Access Compliance Report

Public Rights-of-Way

Intersection ID: N/A	Main Street: INDEPENDENCE_RD	Cross Street: N/A	Location: NE
ADA ID: CB9A24ED3111	Ramp Type: PerpDiag	Initial Pass/Fail: Fail	Overall Compliance: No
Severity Score: 13.75			
Codes/Mitigation Info/Possible Solution		Field Measurements/Component Compliance

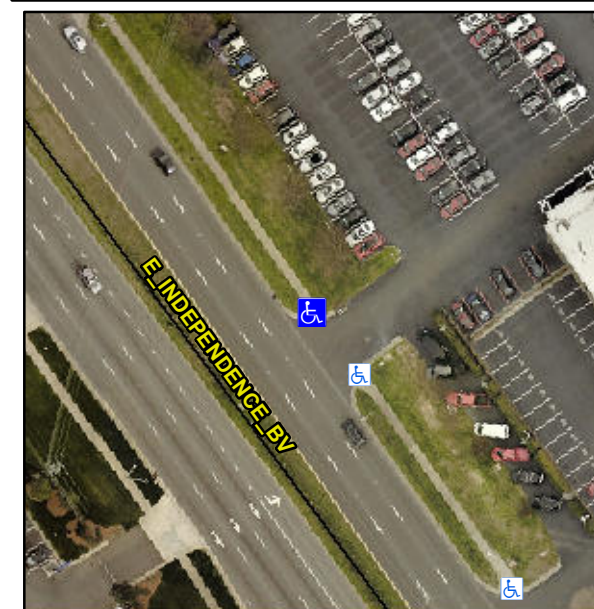
Not Found, R304.2.2

Compliance	Description	Data	Compliance	Description	Data
N/A	Ramp Length (in)	78.0	No	Ramp Slope (%)	11.0
Yes	Ramp Width (in)	48.0	Yes	Ramp XSlope (%)	2.3
N/A	Flare Type LT	N/A	N/A	Flare Type RT	N/A
N/A	Flare Slope LT (%)	N/A	N/A	Flare Slope RT (%)	N/A
N/A	Flare Traversable LT?	N/A	N/A	Flare Traversable RT?	N/A
N/A	Landing Length (in)	N/A	N/A	DWS Provided?	N/A
N/A	Landing Width (in)	N/A	N/A	DWS Contrast?	N/A
N/A	Landing Slope (%)	N/A	N/A	DWS Length (in)	N/A
N/A	Landing X Slope (%)	N/A	N/A	DWS Full Width?	N/A
N/A	Landing Curb? (Y/N)	N/A	N/A	DWS Offset (in)	N/A
N/A	Shared Landing?	N/A			
N/A	Gutter Ponding?	N/A	N/A	Gutter Slope (%)	N/A
N/A	Gutter Lip Ht (in)	N/A	N/A	Gutter X Slope (%)	N/A
N/A	Painted X Walk1?	No	N/A	Painted X Walk2?	No
	X Walk 1 Direction	To W		X Walk 2 Direction	To SE
N/A	X Walk 1 Width (in)	N/A	N/A	X Walk 2 Width (in)	N/A
	X Walk 1 Slope (%)	5.0		X Walk 2 Slope (%)	3.4
	X Walk 1 X Slope (%)	3.7		X Walk 2 X Slope (%)	5.0

Remove & Replace Curb Ramp With Two New Directional Ramps or Equivalent.
